RE: Data Response, Set 3A
San Francisco Electric Reliability Project (04-AFC-1)

**SAN FRANCISCO ELECTRIC
RELIABILITY PROJECT
(04-AFC-1)**

DATA RESPONSE, SET 3A
(Responses to Data Requests: 161-193)

FIGURE CR-174
PROJECT AREA FILL PROGRESSION
SAN FRANCISCO ELECTRIC RELIABILITY PROJECT
SUPPLEMENT A

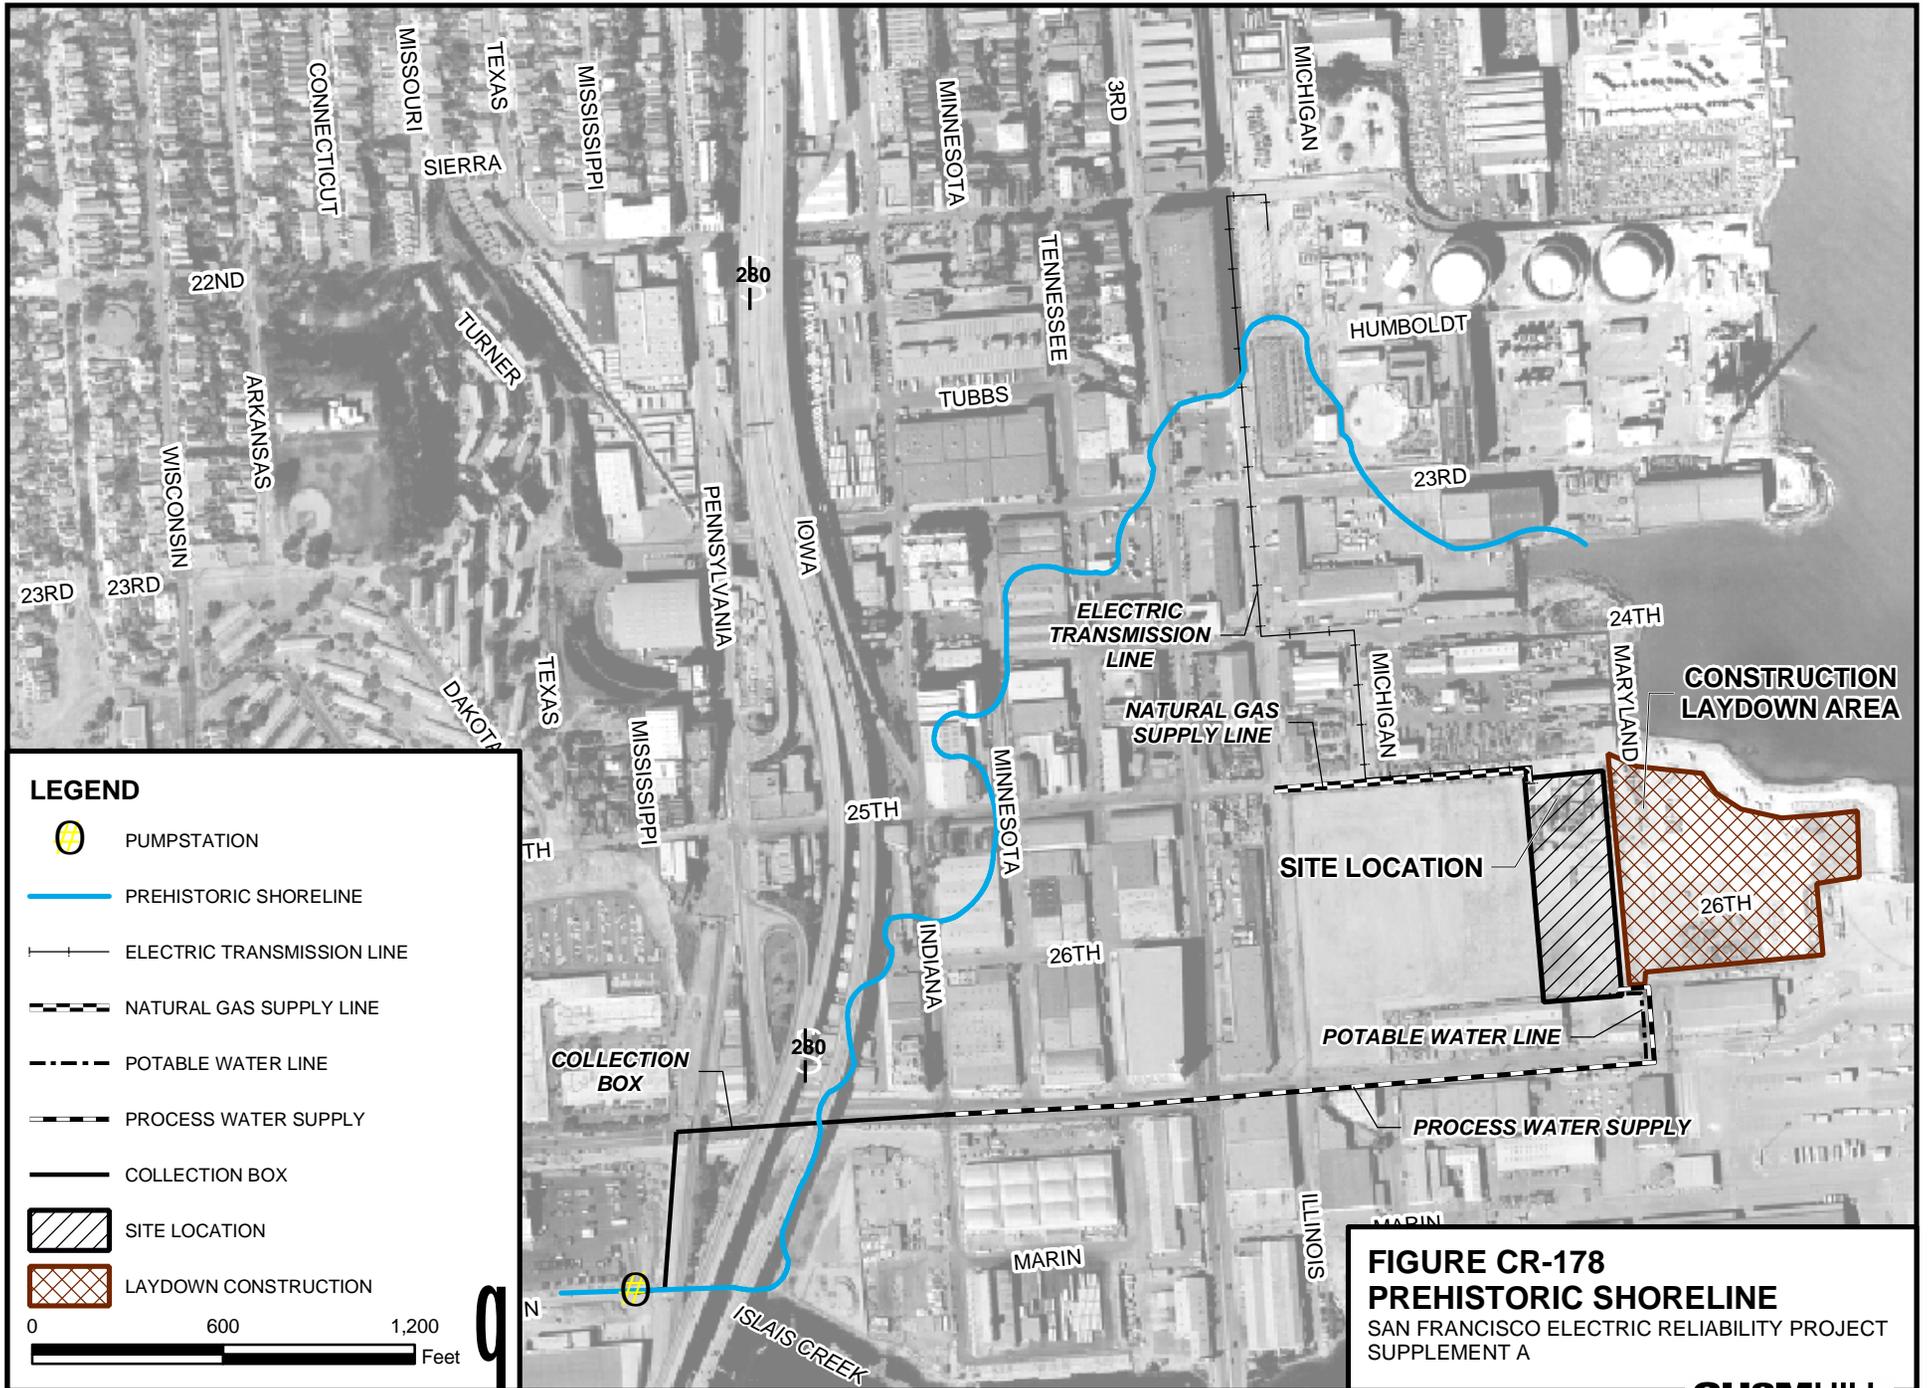
174. Please provide a detailed discussion of the history of the nineteenth and twentieth century filling of the bay in the area bounded by old Potrero Point on the north, Mississippi Street on the west, and Islais Creek on the south, including maps depicting the progression of the filling.

Response: Figure CR-174 depicts the progressive filling of the bay in the project area (source: AGS Inc. 1999). Supplement A provides a detailed discussion of the history of

FIGURE WS-185A

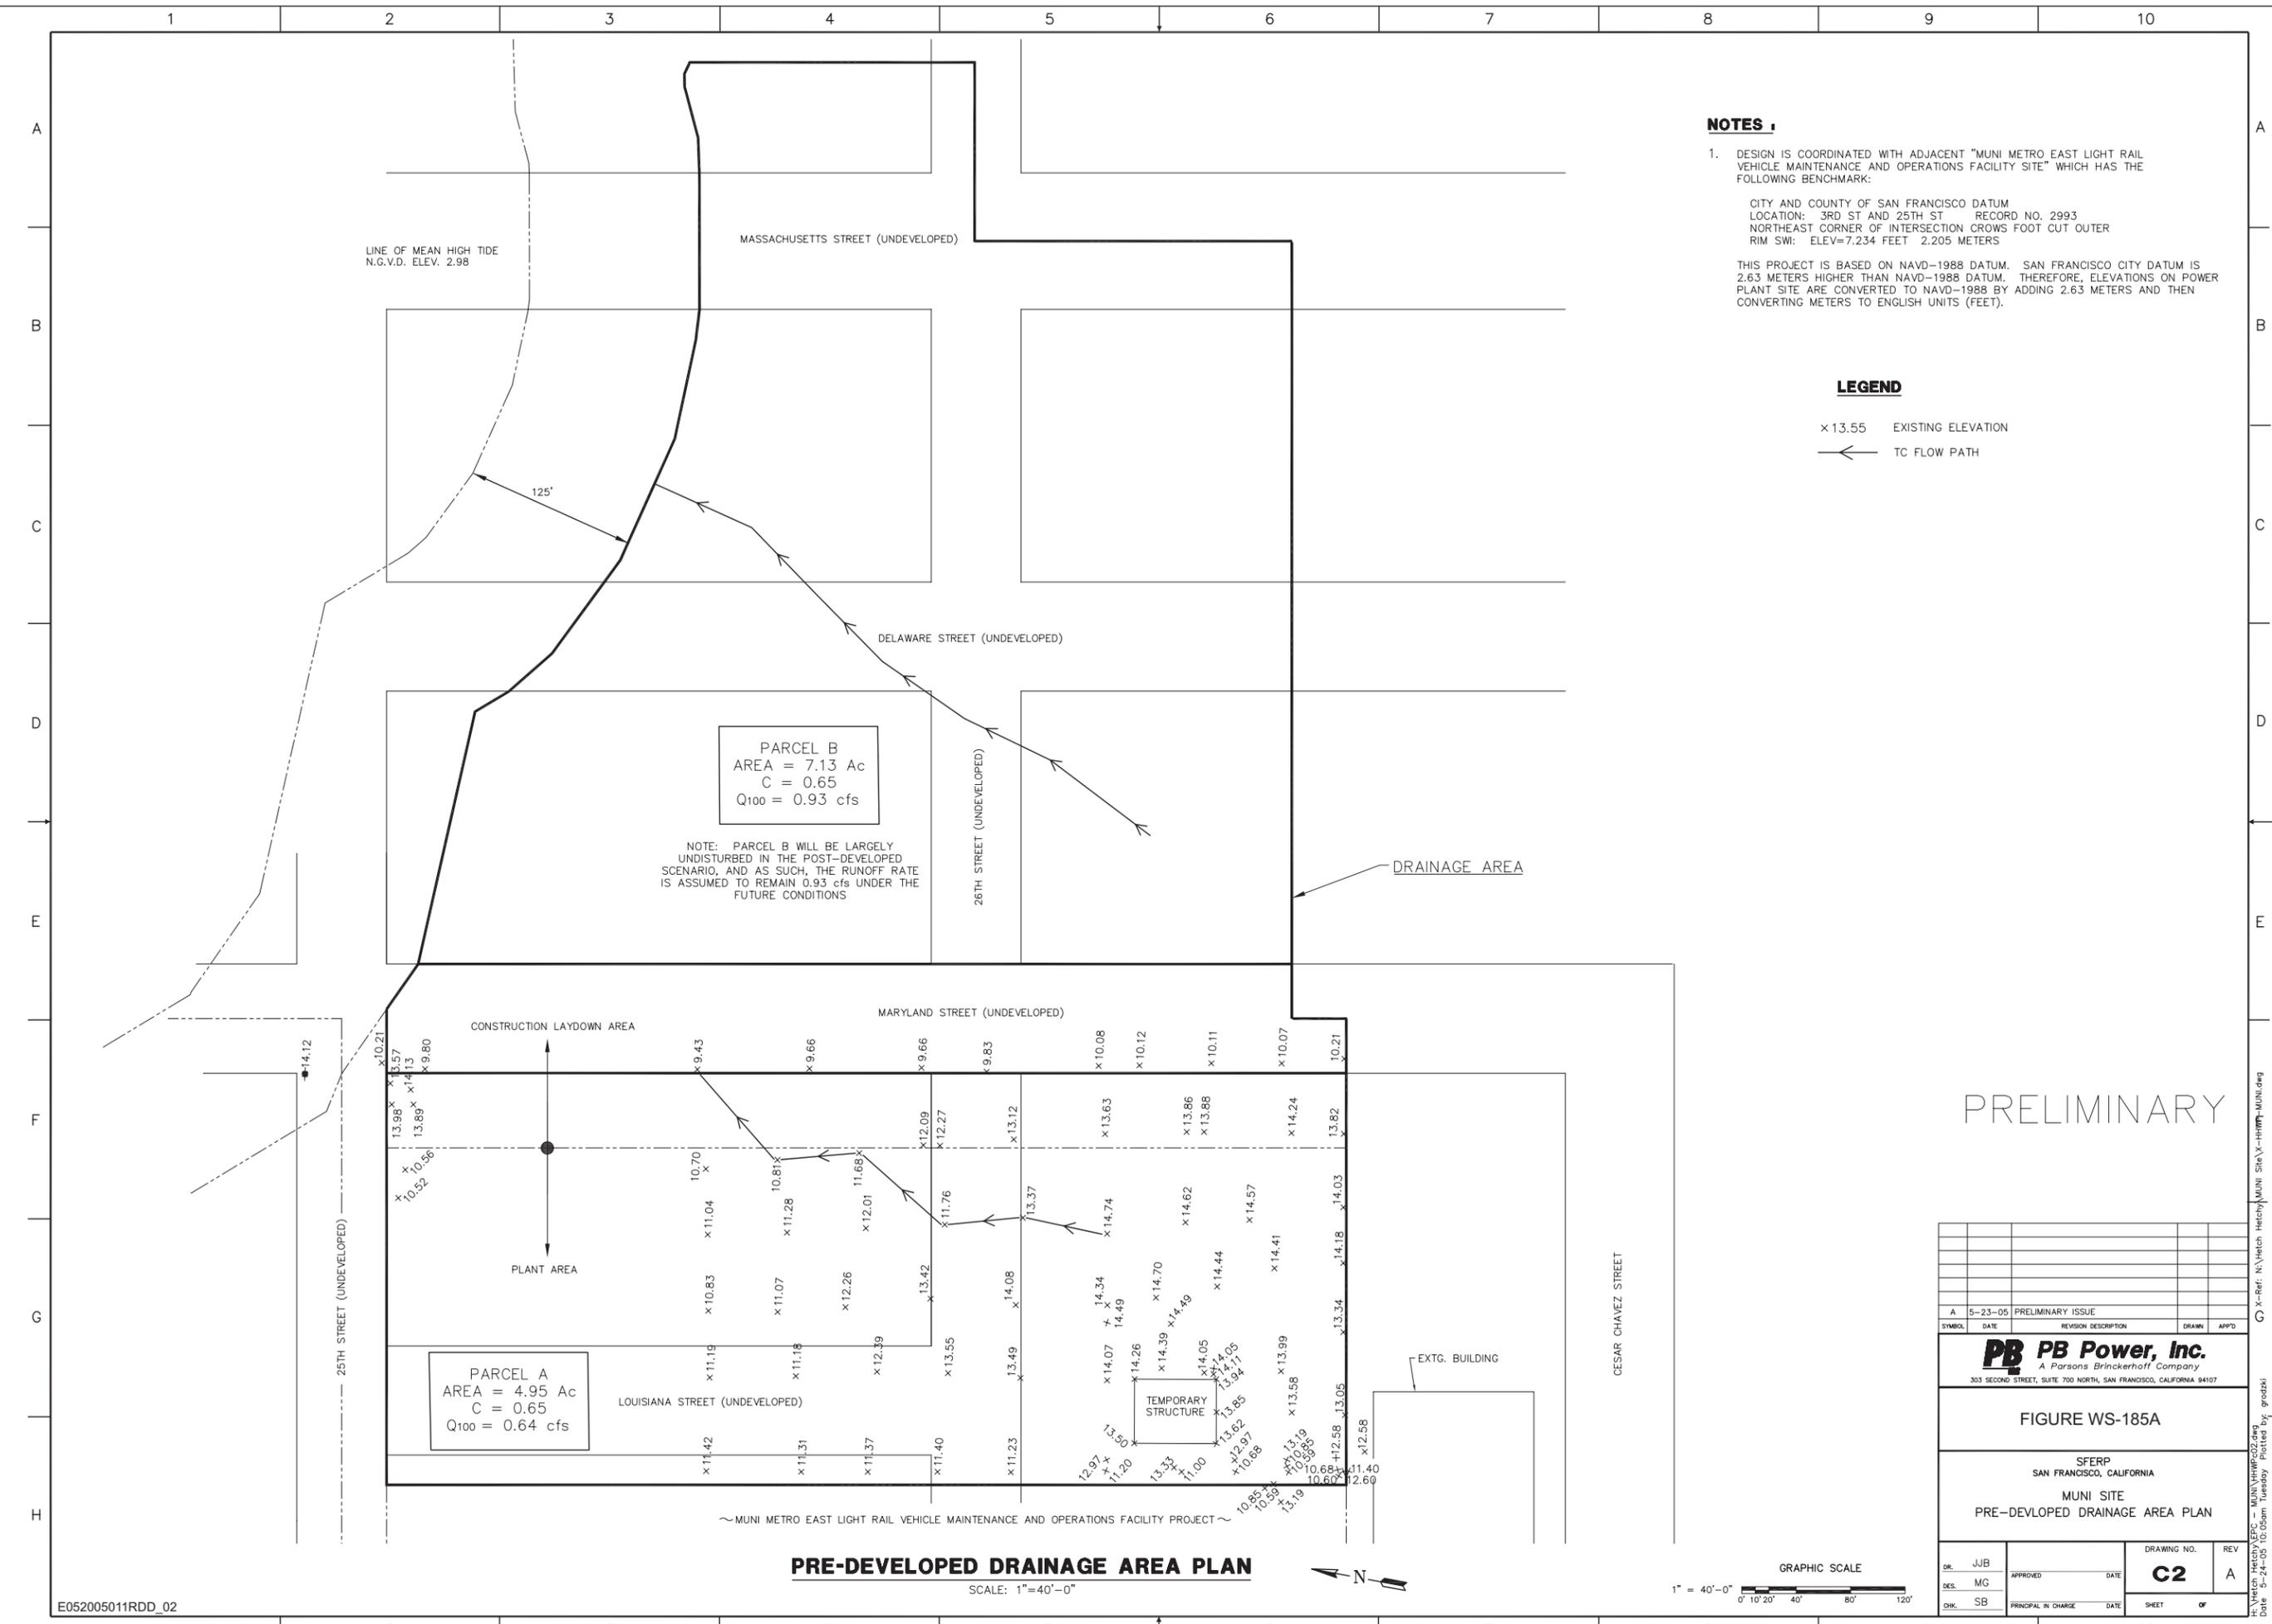
185. Provide the pre- and post-construction runoff and drainage patterns for the 100-year frequency and 24-hour runoff event.

- a) a site map at 1"=100' or less that depicts existing and proposed topography (contours) with labeled elevations, site perimeter, existing and proposed buildings, drainage patterns to stormwater inlets, and on-site and off-site soil stockpile areas;

Response: The pre- and post-construction runoff and drainage patterns are shown on the attached Figures WS-185A and WS-185B.

Response: See Figures WS-185A and 185B.
